**Report To the South Central Area Committee
Meeting: 18th September 2024**

Reference: LAW: Planning and Development Act 2000 (as amended) Planning and Development Regulations 2001 (as amended) – Part VIII

Location: Donore Harriers Athletic Track, Liffey Valley Park, Chapelizod.

Proposal: Proposal for the installation of floodlighting for Donore Harriers Athletics Track in Liffey Valley Park, Chapelizod. The purpose of the proposed flood lighting is to upgrade the existing sports facilities to ensure the availability of, and equal access to sporting facilities for local populations. This proposal also represents a significant investment by Sports Capital Grants and Dublin City Council.

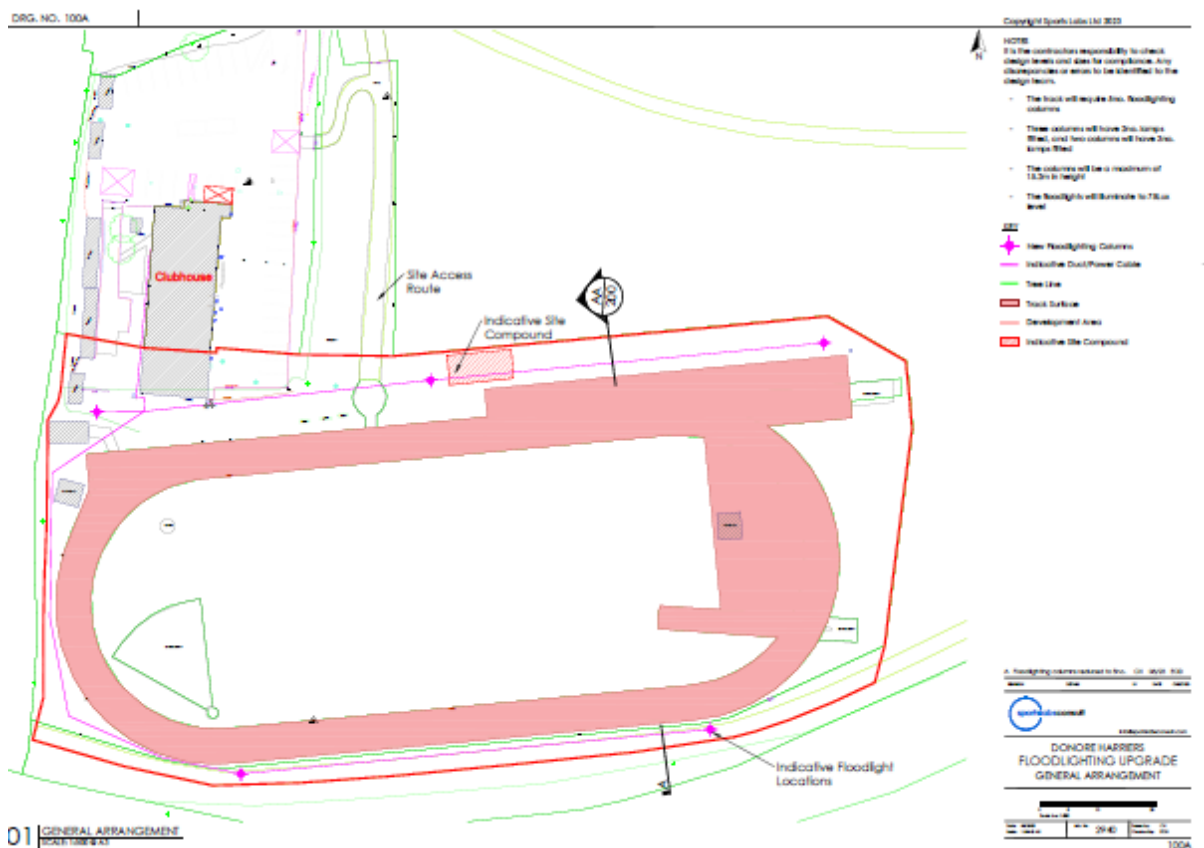
The athletics track facilities at Donore Harriers AC currently has very low level lights that do not achieve any recognised standard for athletics. In order to build on the success the club has achieved in athletic participation, the project now aims to upgrade the athletics track facilities by installing 5 No. new floodlighting columns in order to facilitate intensive winter training.

- 5 x floor lighting columns measuring 15.2m in height;
- Column No's 1-3 fitted with 2 light fixtures, and column No's 4-5 fitted with 3 light fixtures (higher wattage);
- Floodlight foundations are precast concrete bases. These are root mounted, installed via a ground auger and fitted with concrete rings surrounded by mass concrete.
- The power cables will be ducted to protect them and make it easier to repair or install new/more cables as per DCC public lighting specification.
- The ducting will be covered by 450mm under footpaths and 750mm cover will be used under roads.

The luminaire light fitting is fitted in a horizontal plane and is fitted with internal louvres within the hood to mitigate back light spill.
